Airworthiness Directive

AD No.: 2023-0193

FB6 Double Burner Assembly

ATA 28 – Fuel – Hot Air Balloon Burner Assembly and Hanger – Inspection / Modification

Figure 1 – Affected Part

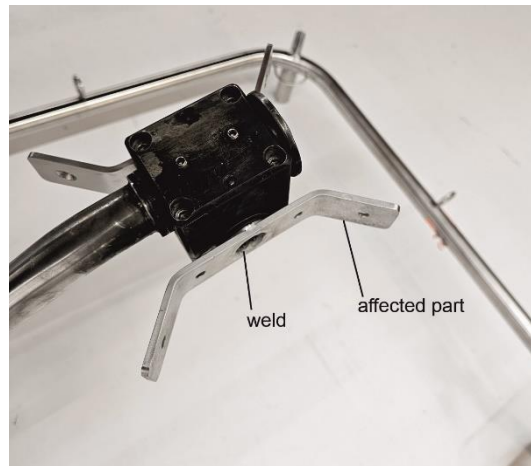
Affected part: Connector of FB6 double burner hanger, except a serviceable part. See Appendix 1 to this AD.

An occurrence was reported of a burner type FB6 S/N 2.1239-1 where the connector between the burners was found detached during transportation, leaving one burner unit detached from the load frame. Investigation revealed that the welding process may have been improperly done, due to an insufficiently detailed description of that process in production. The suspected direct cause of failure is fatigue cracking of the weld, mainly due to improper handling during transportation.

- (1) Within 12 months or 100 flight hours (FH), whichever occurs first after the effective date of this AD, accomplish an inspection of the weld of each affected part, installed on a balloon, in accordance with the instructions of the TN.

- (2) If, during the inspection as required by paragraph (1) of this AD, any crack is detected or evidence of a weld with insufficient filler material is found, before next flight, replace the affected part with a serviceable part, in accordance with the instructions of the TN.

- (3) If, during the inspection as required by paragraph (1) of this AD, sufficient filler material, as defined in the TN, is found on an affected part, before next flight, mark that part in accordance with the instructions of the TN.

- (4) From the effective date of this AD, do not install an affected part, or a burner assembly having an affected part installed, on any balloon.
